AGENDA

Planning Commission Regular Meeting

Tuesday, October 22, 2024

AGENDA ITEM:	Request by DevCo Preservation, LLC, for PUD Final Site and Building Plan Approval.	AGENDA SECTION:	PUBLIC HEARINGS
PREPARED BY:	Anthony Nemcek , Senior Planner	AGENDA NO.	6.c.
ATTACHMENTS:	Site Location, Land Use, Zoning, Architectural Site Plan, Civil Site Plan, Architectural Plans, Preliminary Landscape Plan, Utility Plan, Lighting Plan and Photometric Study, Engineer's Memo Dated October 17, 2024	APPROVED BY:	AK
RECOMMENDED ACTION: Motion to approve the Planned Unit Development Final Site and Building Plan allowing DevCo Preservation LLC to construct a multi-unit residential development, subject to the following conditions: a. Approval of a zoning ordinance text amendment to Section 11-7-6: Landscaping, Screening, and Buffering Standards. b. Submittal of a landscaping surety equal to 110% of the cost of trees based on \$350 per tree. c. Conformance with all requirements of the City Engineer detailed in the attached memorandum dated October 17, 2024. d. Approval of a final plat to convert the outlot into a buildable lot. e. Approval by Council of a minor amendment to the Emerald Isle PUD to waive

① SD Site Plan
1" = 100'-0"

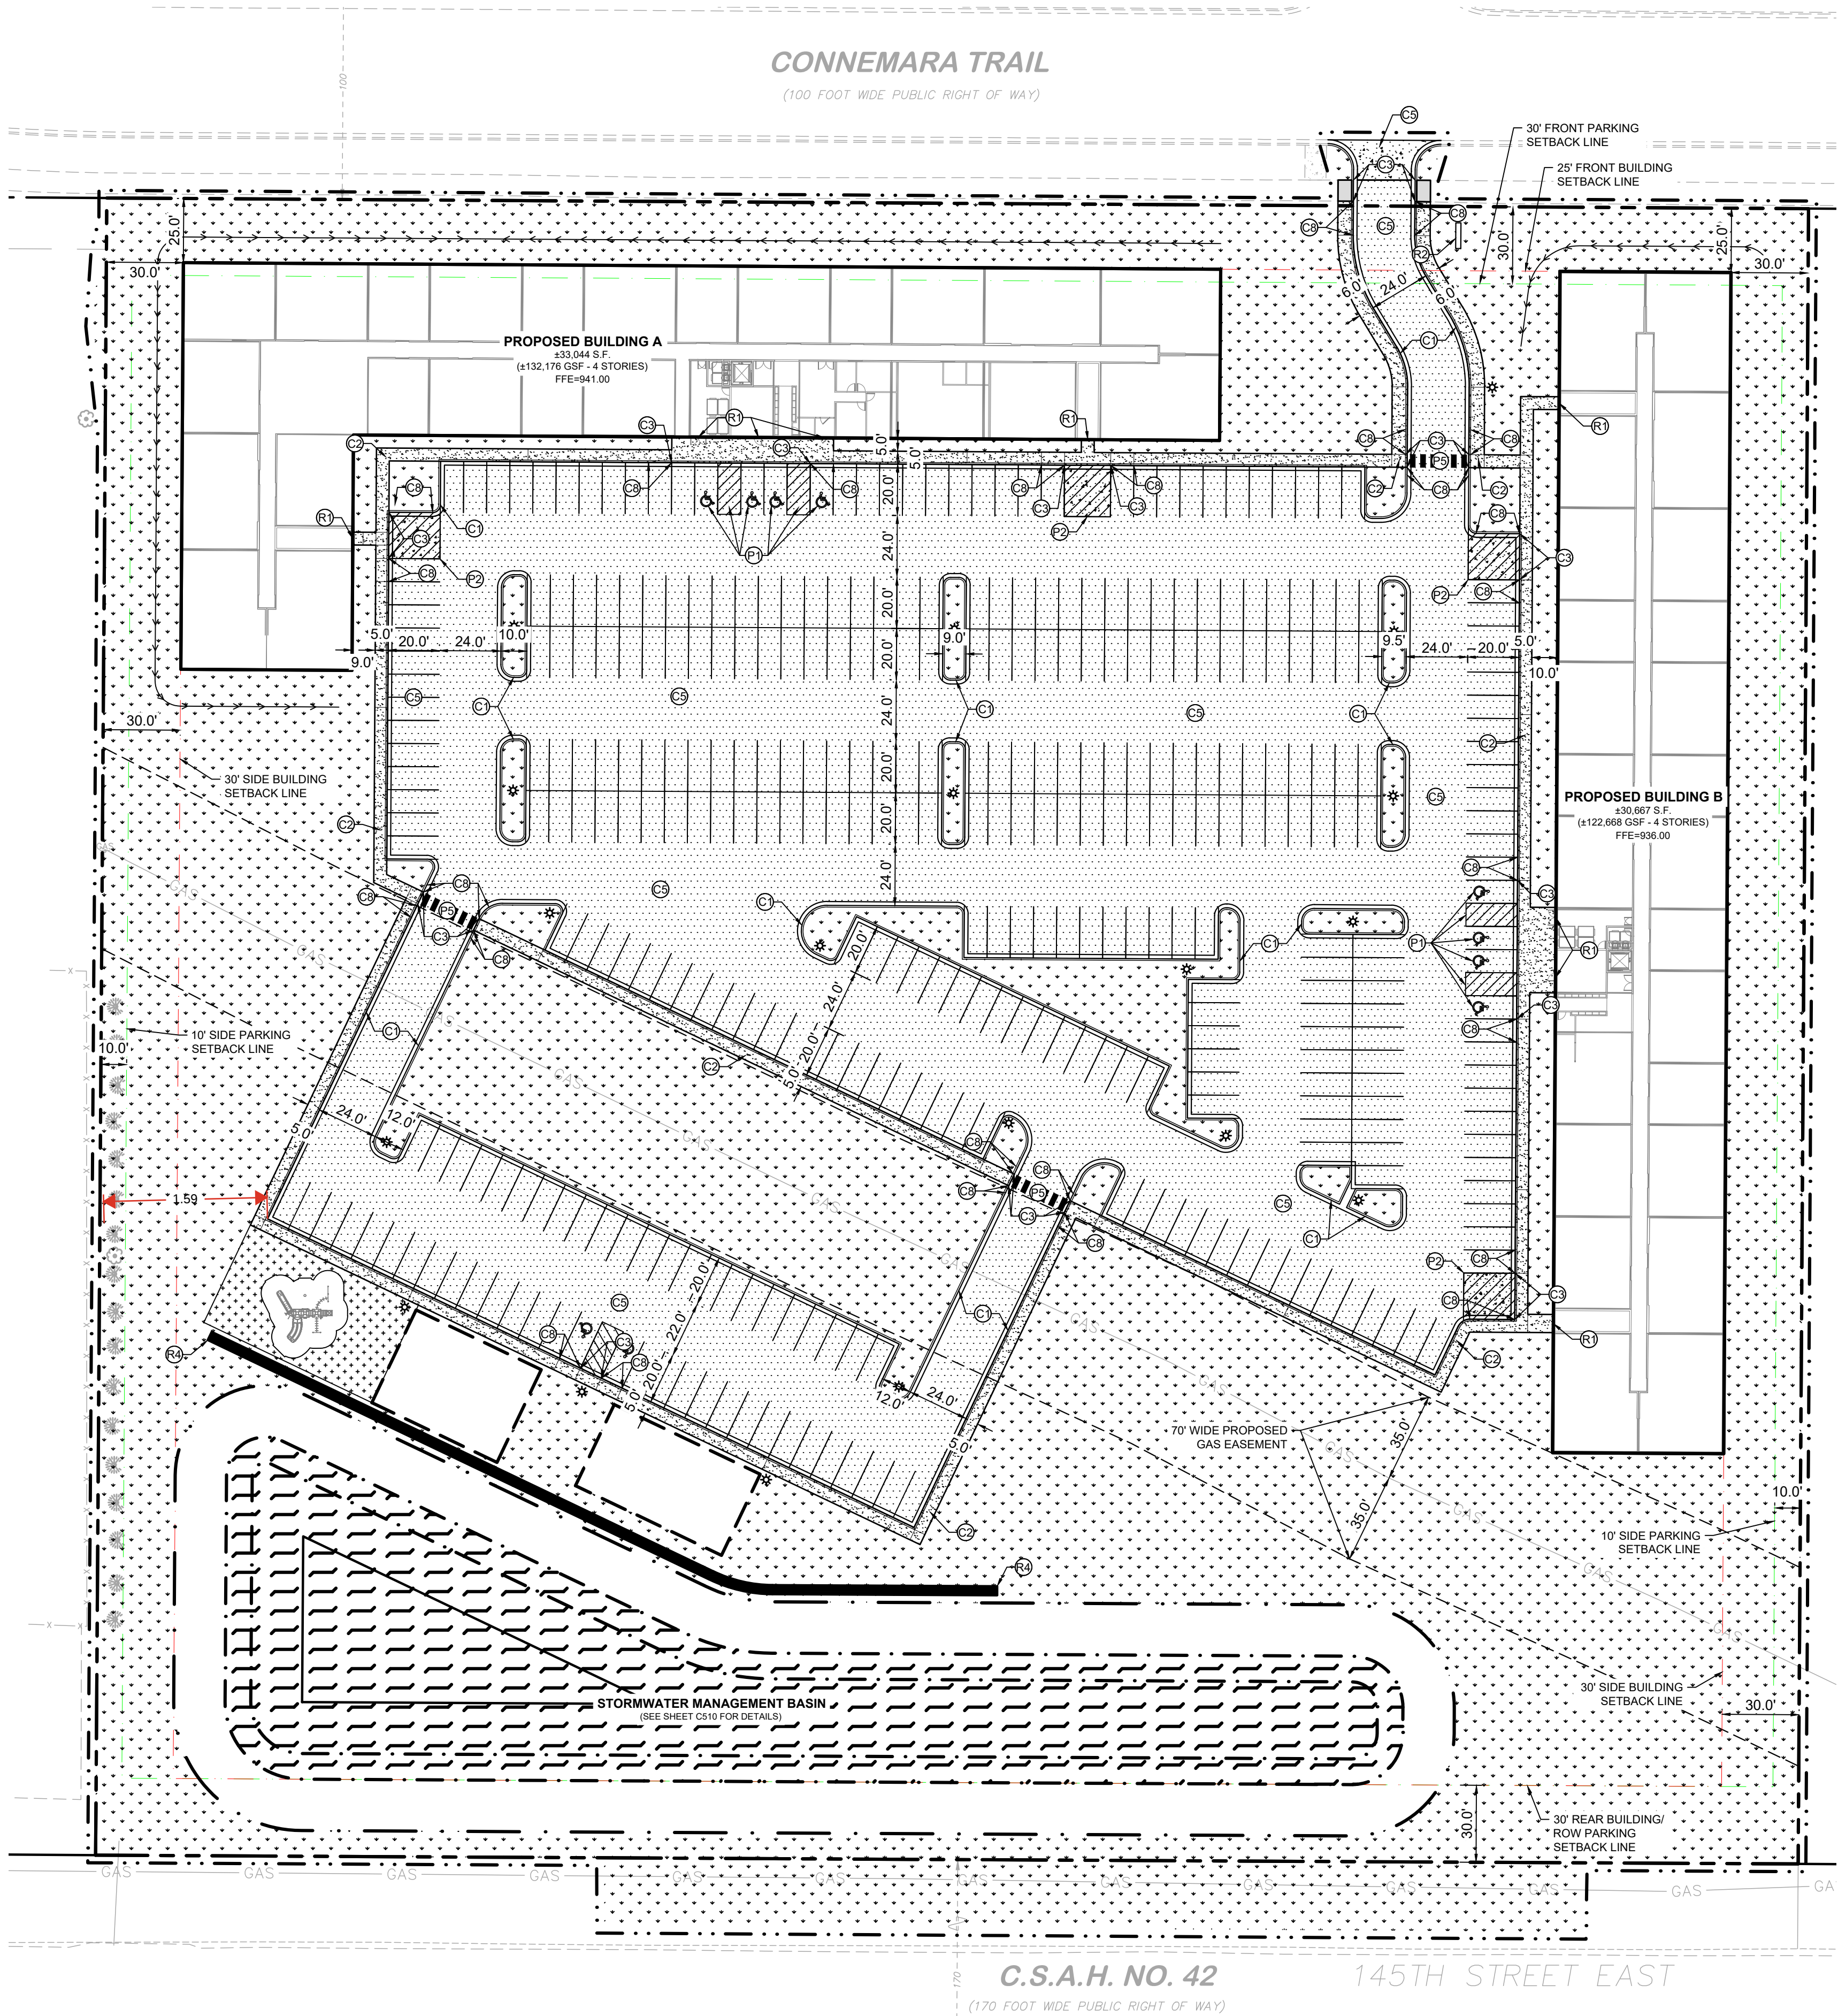
recommending a standard of 1 tree per 1,500 square feet of pervious area (excluding areas within easements containing infrastructure and within the normal water level of ponding areas). The applicant has provided a preliminary landscape plan that, when calculated excluding the gas pipeline easement and area below the normal water level of the pond, has a ratio of 1 tree per 942 square feet of pervious area. Staff finds the landscape plan to be too crowded even at that ratio, which is driving the recommendation for a ratio of one tree per 1,500 square feet. This results in a requirement of 89 trees plus the required 37 trees within the parking lot area. The previous standard would have required over 200 trees, and a general ratio of 1 per 3,000, as is standard in other non-residential zoning districts, would require 142 trees for this site.

The landscaping plan also includes foundation planting and parking lot landscaping. The parking lot landscaping requirement is based on a ration of one tree per 10 parking spaces. With 363 spaces, staff calculates a need for 37 trees. The applicant's plan should be updated to provide an additional tree in the parking lot area. Also, as required by the zoning ordinance, trees are shown along public rights of way at 50' intervals.

As provided, the landscaping plan meets the standard being proposed by staff as an amendment to the zoning ordinance text, as crowded as it is. Staff will continue to work with the applicant to dial in their final landscaping plan to ensure it is reasonable and provides use of the site while still meeting the proposed zoning code standard. A condition of approval included with the recommended action is the adoption of a zoning ordinance text amendment related to landscaping. Lastly, the Code requires the submittal of a landscaping surety equal to 110% of the cost of landscaping based on a value of \$350/tree. Staff will determine the actual amount of the surety once the final number of trees to be planted is determined.

The site plan provides sidewalks that allow for pedestrian access to Connemara Trail and surround the parking areas. Sidewalks also provide pedestrian access to the site amenities in the southern portion of the site. Not offsite improvements, such as a bituminous trail along Connemara, are required as it has already been installed with the extension of that road.

The site plan indicates an anticipated location for a monument sign near the entrance along Connemara Trail. As is always the case, signage will be approved administratively through the sign permitting process.

1 ELECTRICAL SITE PHOTOMETRIC PLAN
SCALE: 1" = 30'-0"

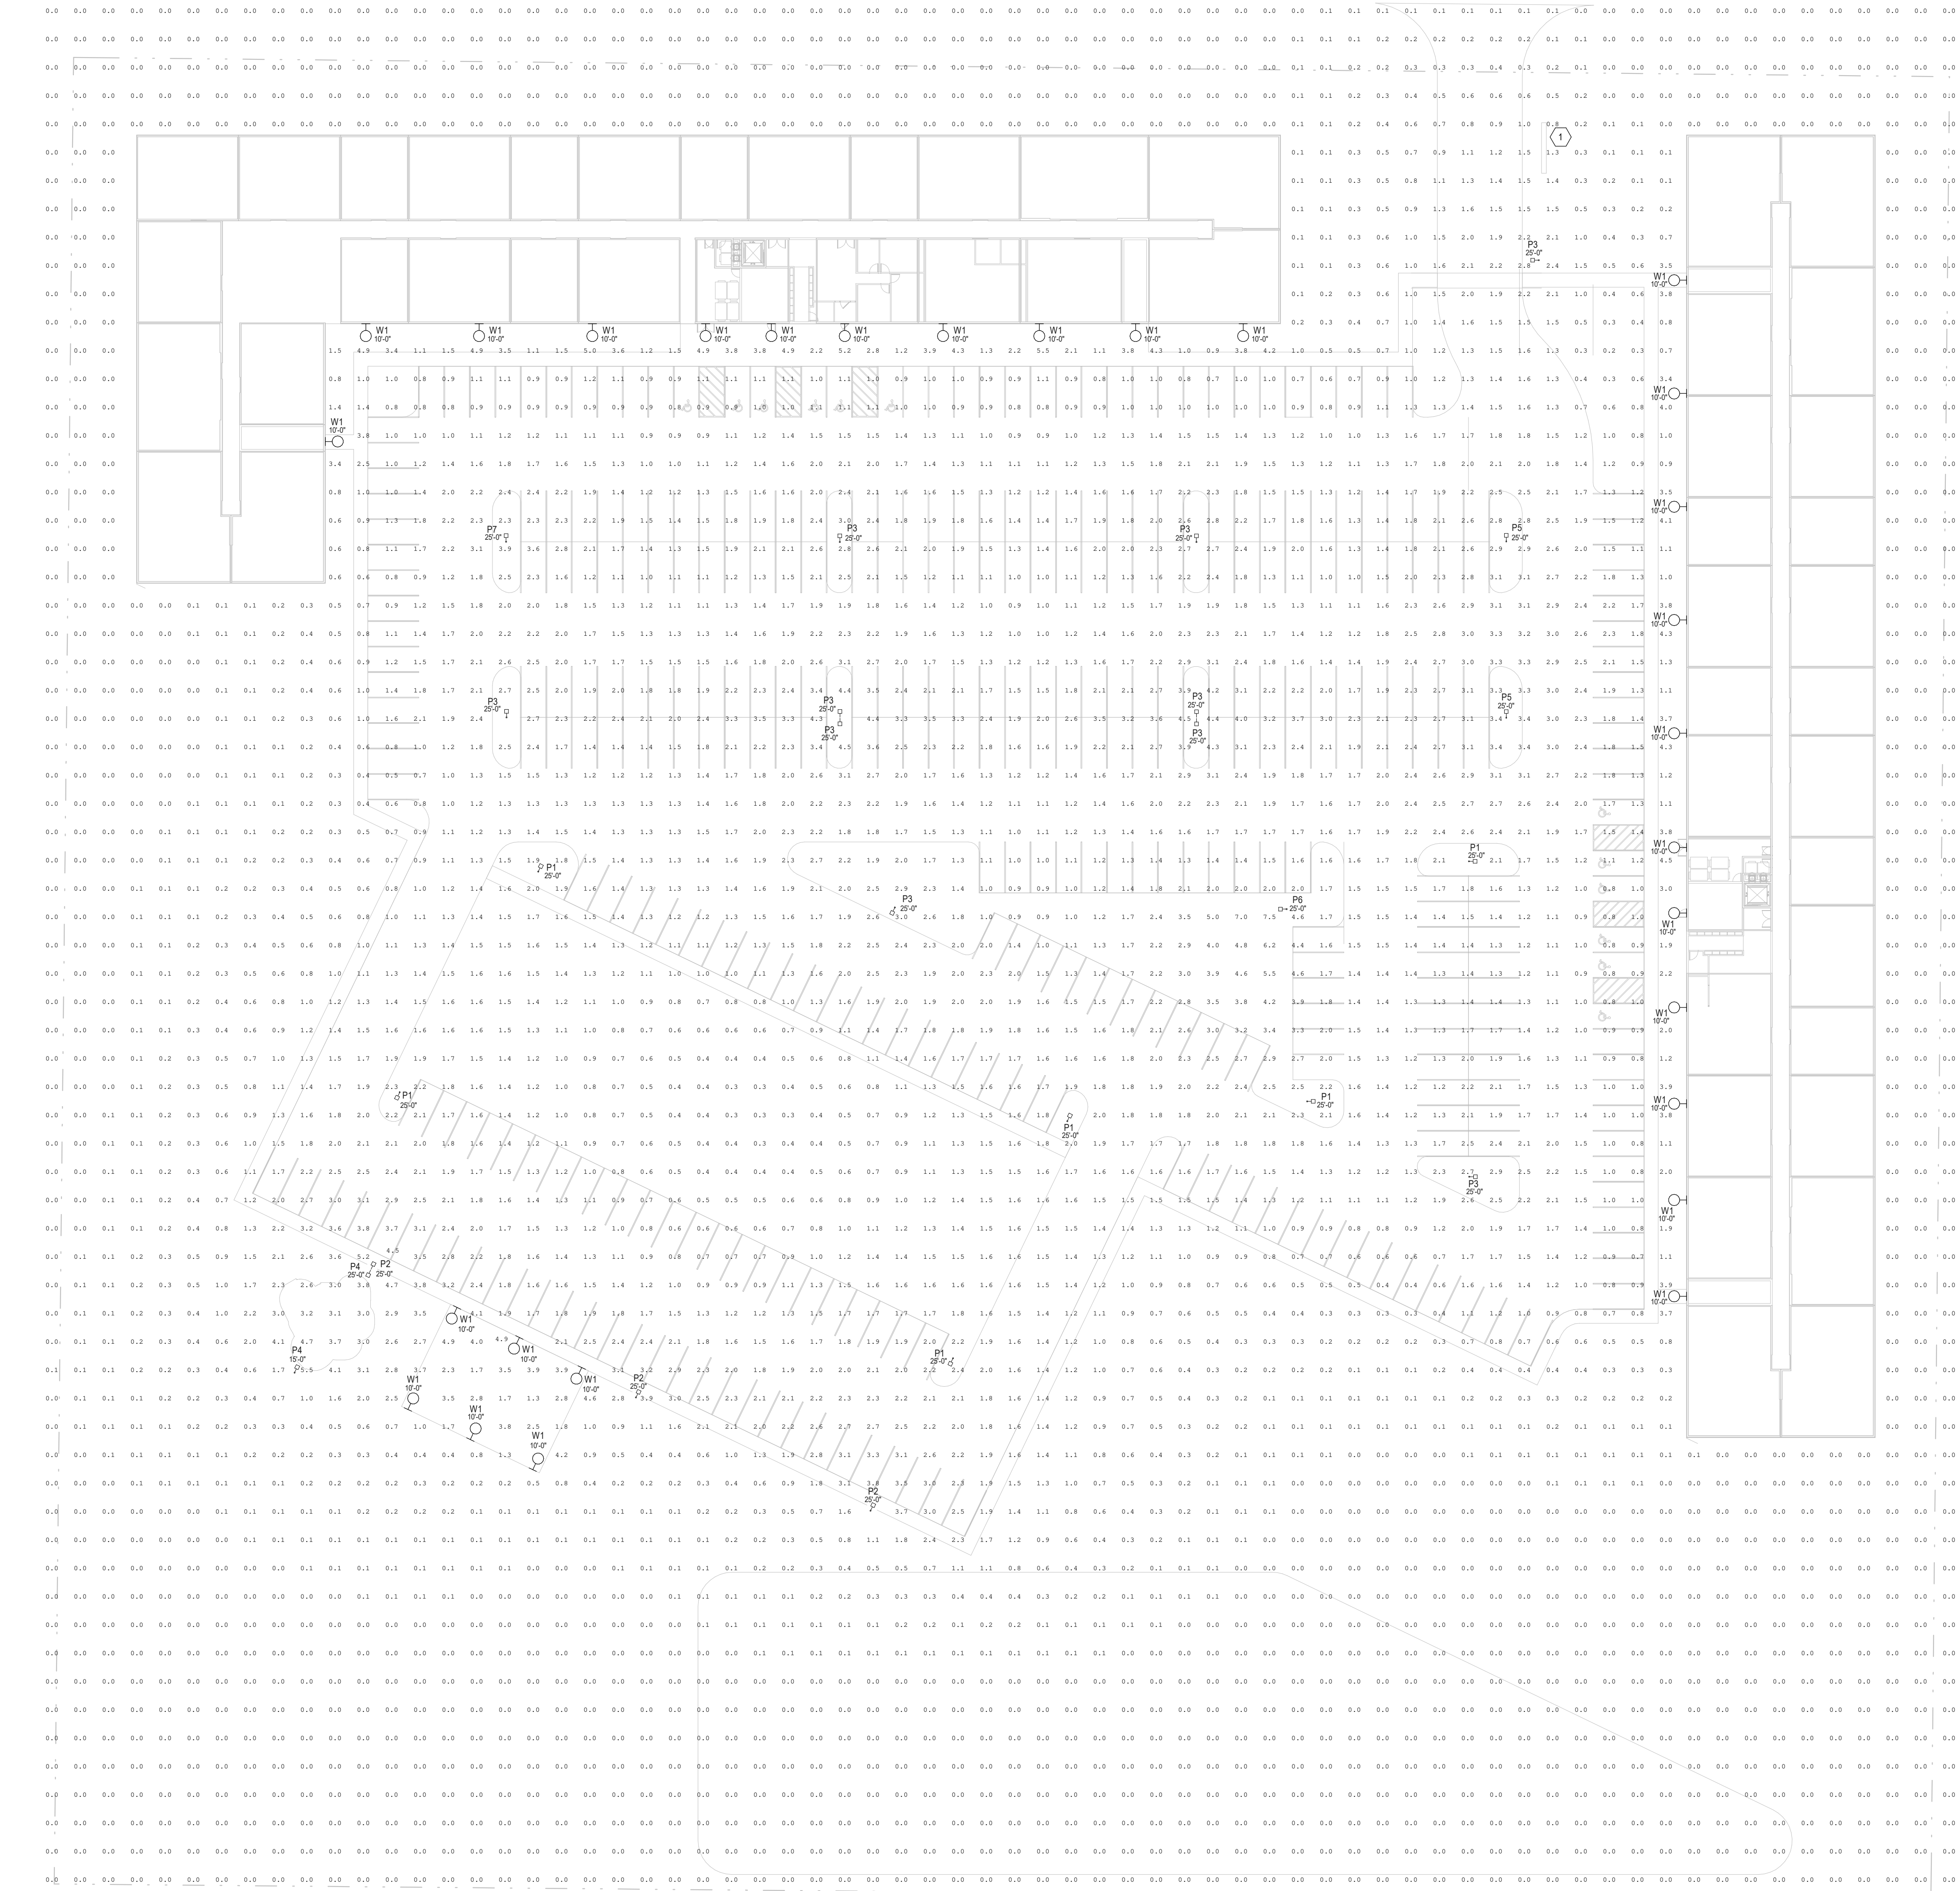
The applicant provided a lighting plan with photometric analysis as part of their submittal. This is included in the attachments. The site will be lit with lights mounted on walls at 10' in height and on 25' poles, which are below the maximum of 30'. The code contains a provision that the maximum height is 20' within 100' of a residential use, and all poles are well over 100' from any adjacent residential uses.
